REVIEW OF ORICA SOUTHLANDS REMEDIATION and DEVELOPMENT

HYDRAULIC MODELLING REPORT and RESPONSE to EXHIBITION SUBMISSIONS/COMMENTS

DEPARTMENT OF PLANNING and INFRASTRUCTURE

AUGUST 2011

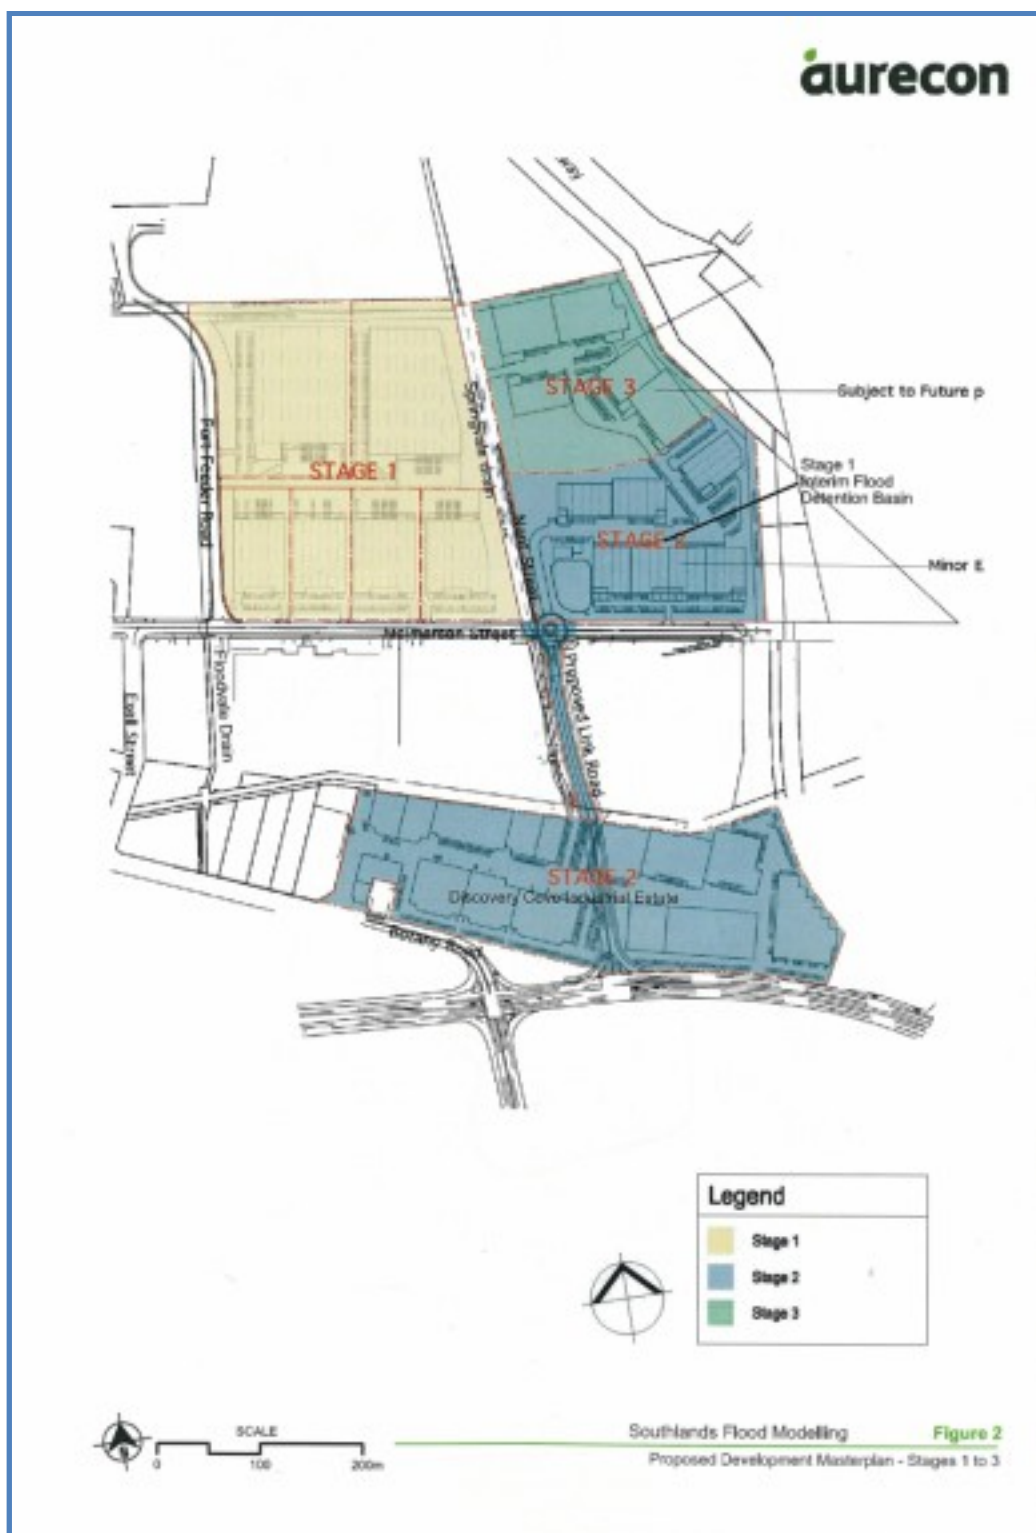
The proposed development is to be undertaken in three stages (see diagram below) but the application (and our review of the assessment) is only for Stages 1 and 2.

Our comments have been summarised under Stage 1 and Stage 2.

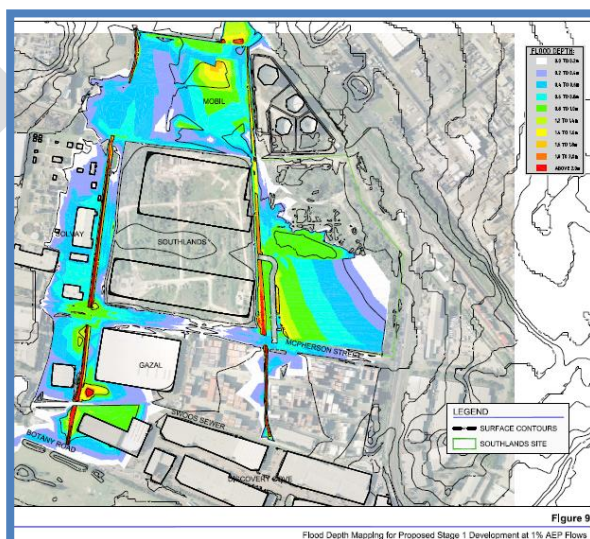
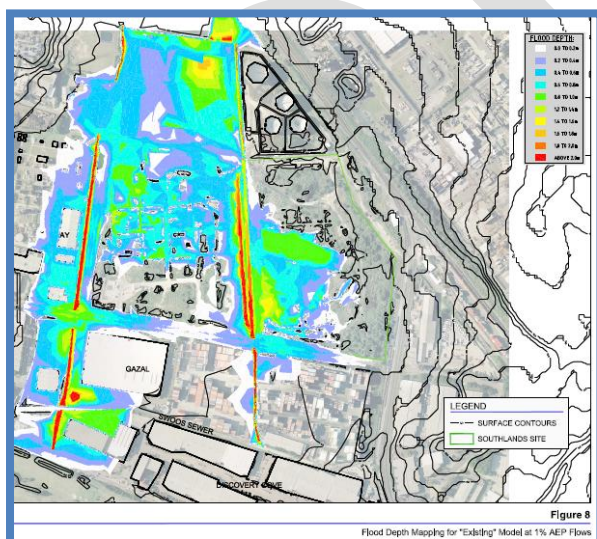
The report states *"it is assumed that the existing drains and other structures are clean and function as they were originally designed"* (Page 10). This assumption is clearly not valid as the following photographs (taken from the report) illustrate that the existing drainage system is already partially blocked (the report also states that both drains are *"heavily blocked with silt and debris"* and *"the culverts are currently severely blocked"*) and includes structures (small openings, vegetative debris, pipes and railings crossing the channel) conducive to a high level of blockage during a flood.

Existing conditions MUST relate to what is there at present (i.e considerable blockage) and for design it cannot be assumed that this blockage will be removed unless some form of blockage minimisation device or maintenance is included. These devices will only be accepted if it can be demonstrated that they will work as designed and be properly maintained for the life of the project. It cannot be assumed that Council or any other authority will undertake this task.

An assessment of blockage of ALL culverts and waterway openings therefore needs to be considered in the existing v design flood assessment as well as for the setting of Flood Planning Levels.

A suggestion is to assign a % blockage to each structure based on a review of the structure as they exist today and use this same value for all subsequent hydraulic analysis (identical values for existing and design). The SWOOS and McPherson Street crossings are likely to have >70% blockage.
